**Re: Letter of Notification of PPL Electric Utilities Corporation, Filed Pursuant to 52 Pa. Code Chapter 57 Subchapter G, for Approval of the Glen Brook Substation 230 kV Connecting Lines Project in Salem Township, Luzerne County, PA
Docket No. P-2019-3012353**

Enclosed for filing are the responses of PPL Electric Utilities Corporation to the Bureau of Technical Utility Services Data Requests as follows:

PPL Electric Utilities Corporation
Response to Data Requests of
Bureau of Technical Utility Services
Dated November 12, 2019
Docket No. A-2019-3012304

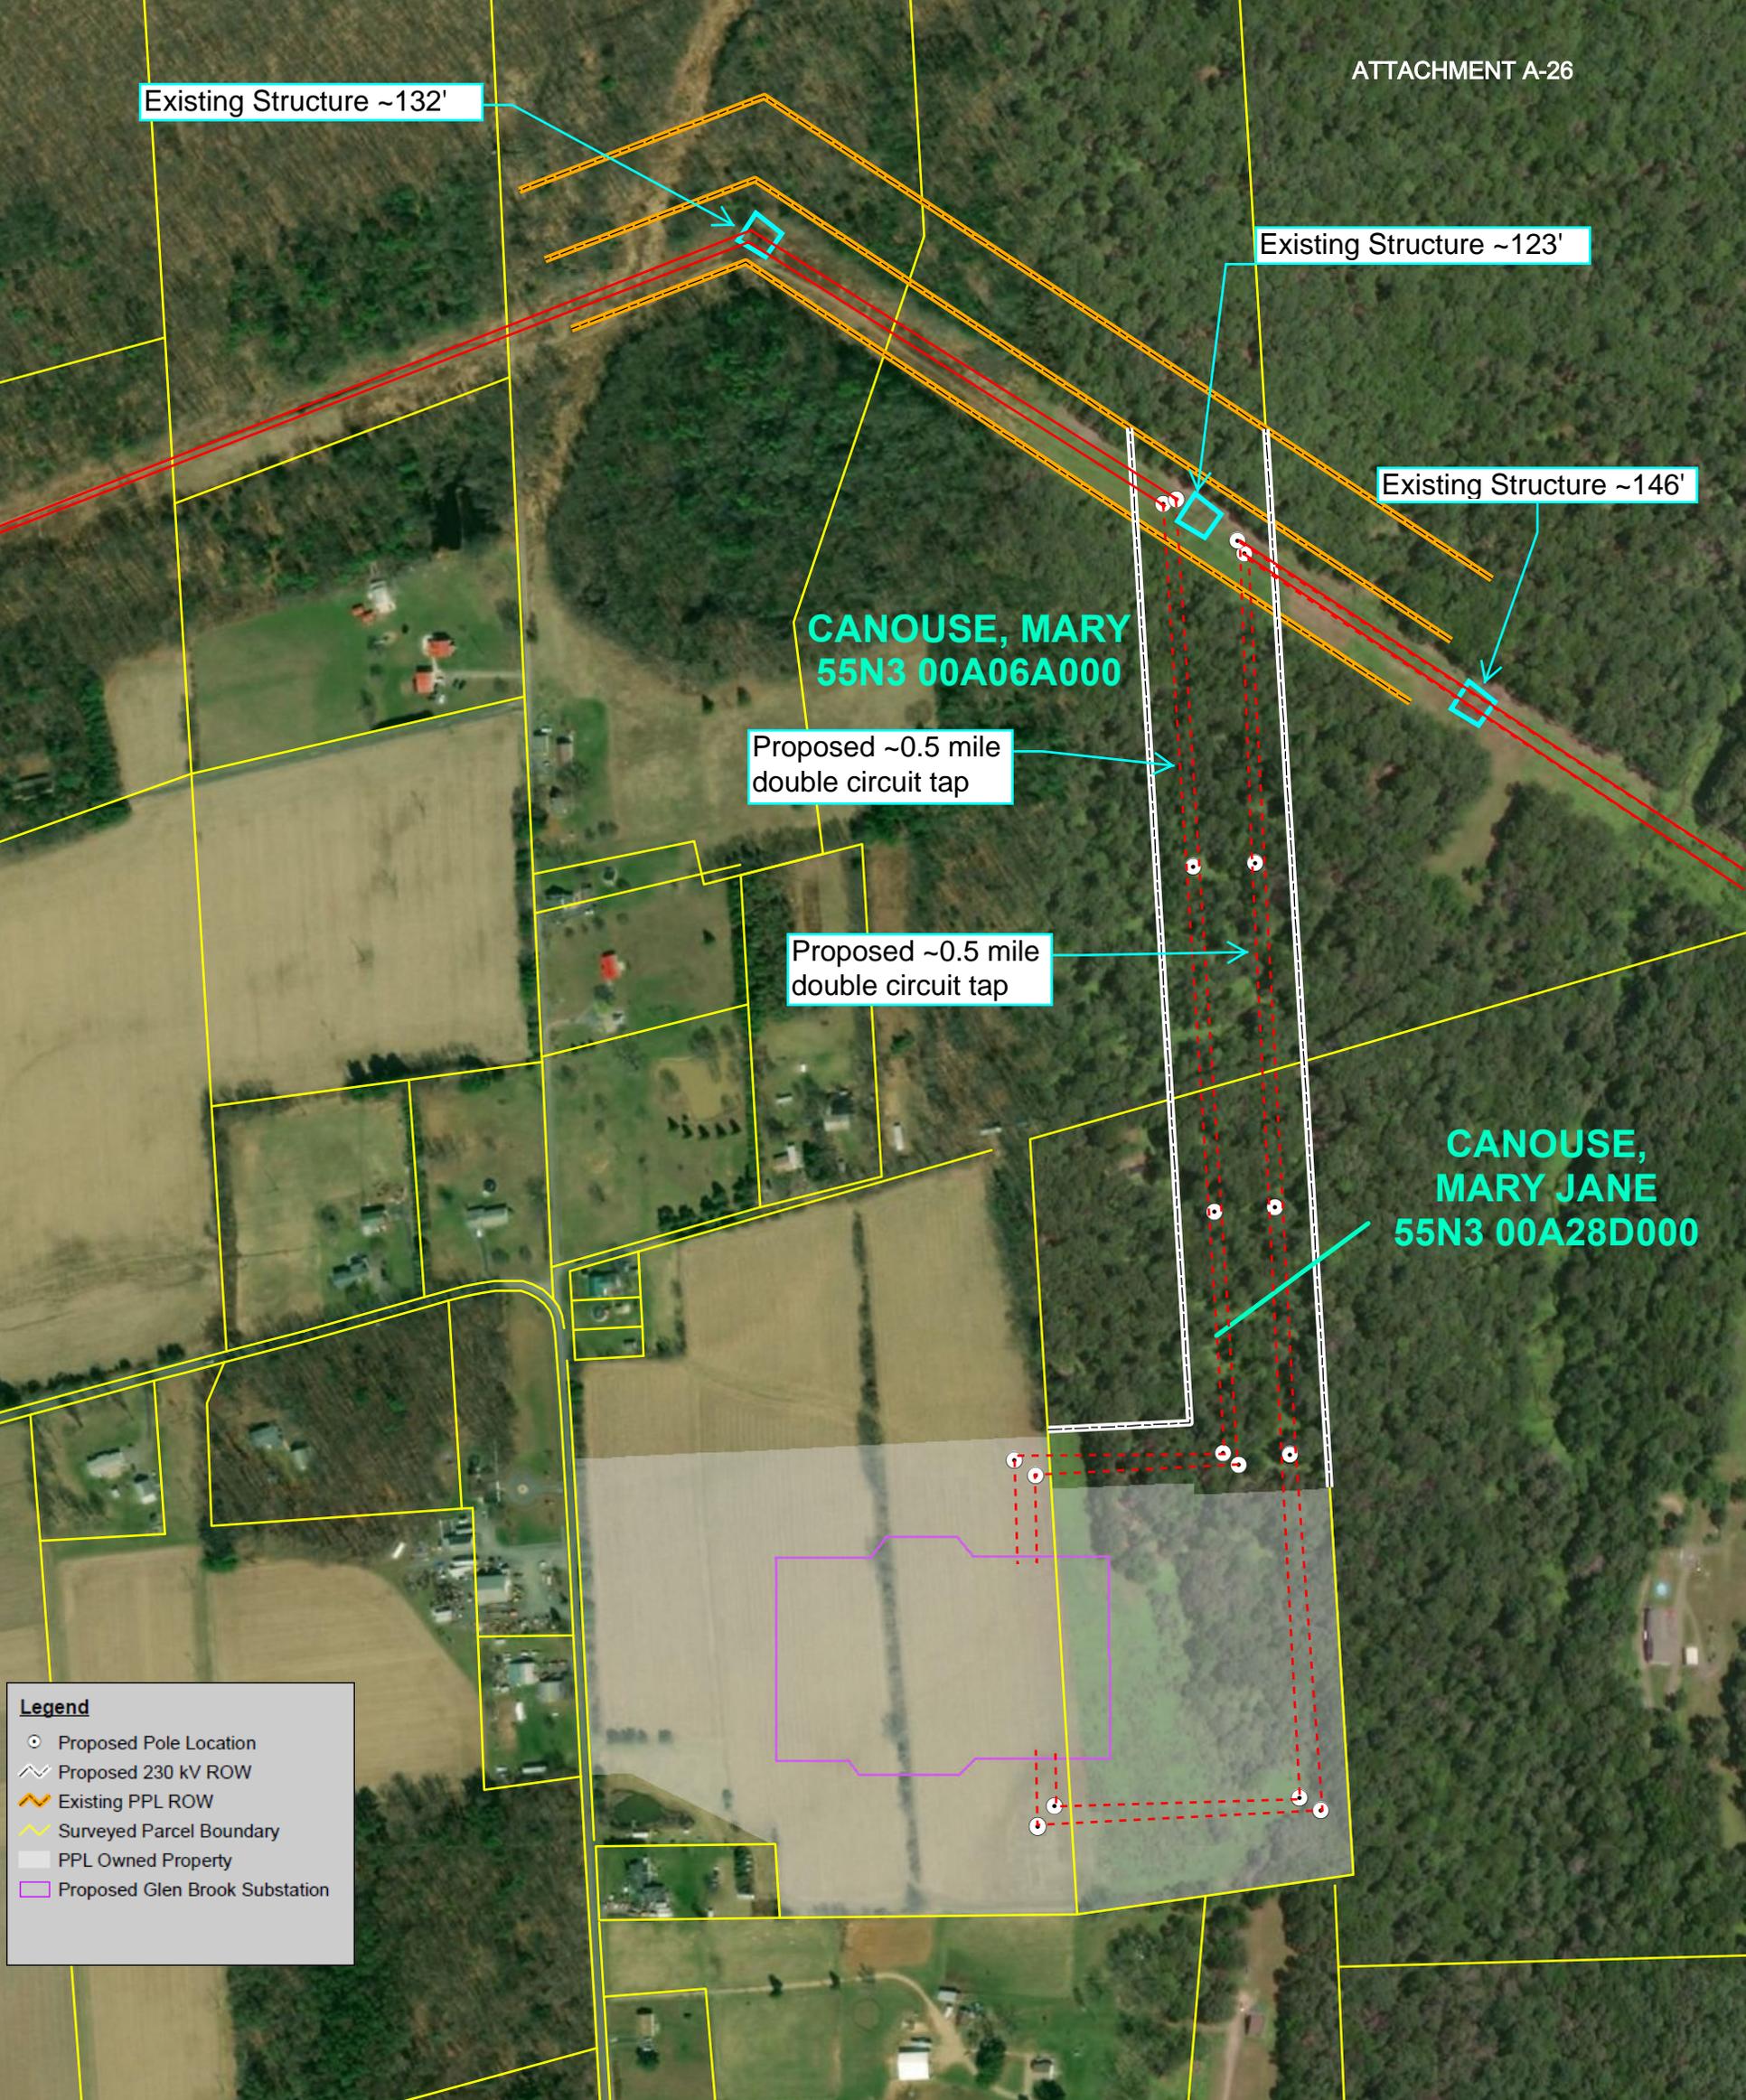
Reference the Letter of Notification, Paragraph 22. Please state the total number of 230 kV transmission line taps to be constructed and provide the approximate length of each tap.

Two new parallel 230 kV transmission line taps will be constructed. The two new transmission taps will extend from the existing Montour-Susquehanna and Montour-Susquehanna T10 230 kV transmission lines to the new Glen Brook Substation. Attachment A-26 depicts the two new 230 kV double circuit transmission taps.

Proposed ~0.5 mile
double circuit tap

Proposed ~0.5 mile
double circuit tap
